**EXHIBIT B: Comments Received with Staff Responses**

TX16-01: Minor Text Amendment to Subdivision Code

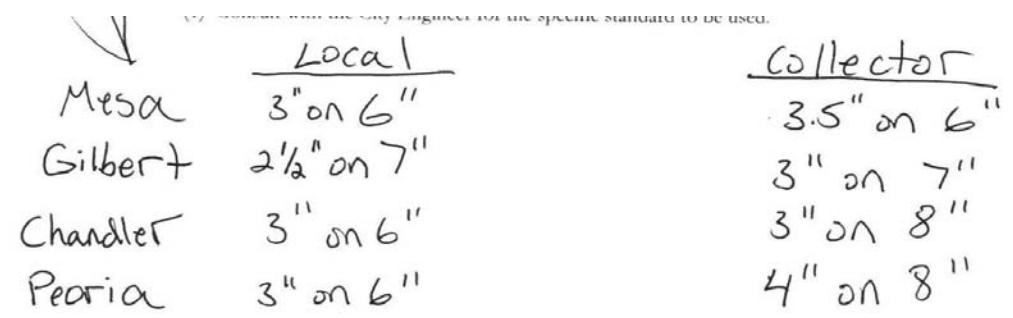
25	Requires two points of access for a 5 lot rural residential subdivision. Not sure what the Fire Code requires, but allowing so many lots before a 2nd access is required is common.	Section 14-6-6, p. 6.14	Declined	This comment will be considered for review as part of the city's major text amendment of the code that is scheduled for Summer 2017.															
26	Definitions, 58, Lot Width – I think the example lots are switched.	Section 14-1-6 (58), p. 1.6	Declined	This comment will be considered for review as part of the city's major text amendment of the code that is scheduled for Summer 2017.															
2nd Reading: 15 Day Public Comment Period																			
27	I was looking at the text amendment again today and just noticed the collector pavement section of 5" on 10". That is crazy for a collector, that's almost a freeway section. That is a very excessive section for a residential collector. The engineering certainly does not call out for this excessive of a section for the minimal spec. I don't believe the other major municipalities have that thick of section either. You guys might want to look at that one. - Shane Graser	Sec. 14-6-8 (table 4), p. 6.21	Declined	The collector structural road section thickness is already in code which is not being revised at this time. Public Works Engineering Department is not recommending any changes to the existing structural standard for collector streets.															
28	Street sections from various municipalities:   <p>The handwritten table shows the following data:</p>

Local	Collector	Mesa	3" on 6"	3.5" on 6"	Gilbert	2 1/2" on 7"	3" on 7"	Chandler	3" on 6"	3" on 8"	Peoria	3" on 6"	4" on 8"	Sec. 14-6-8 (table 4), p. 6.21	Declined	Comparable structural street section analysis was done and found to be comparable to other communities such as Glendale, Surprise, and Goodyear.
	Local	Collector																	
Mesa	3" on 6"	3.5" on 6"																	
Gilbert	2 1/2" on 7"	3" on 7"																	
Chandler	3" on 6"	3" on 8"																	
Peoria	3" on 6"	4" on 8"																	
29	Major concern is with Design Standards, Section 14-6-8, Street Design, Paragraph J – Structural Section (i.e. Table 4). Our review of comparable local municipalities standards (including Gilbert, Mesa and Chandler) showed the proposed City of Maricopa Structural Sections, not to be in conformance with accepted norms, but to be over designed, placing a substantial additional cost burden on the developer/homebuilder, and essentially on the home buyer. Based on construction cost estimates provided by contractors, the additional cost to construct the new proposed sections versus the Geotechnical Engineers recommended design sections (typical) result in additional cost of over \$2,500/finished lot.	Sec. 14-6-8 (table 4), p. 6.21	Declined	Comparable structural street section analysis was done and found to be comparable to other communities such as Glendale, Surprise, and Goodyear.
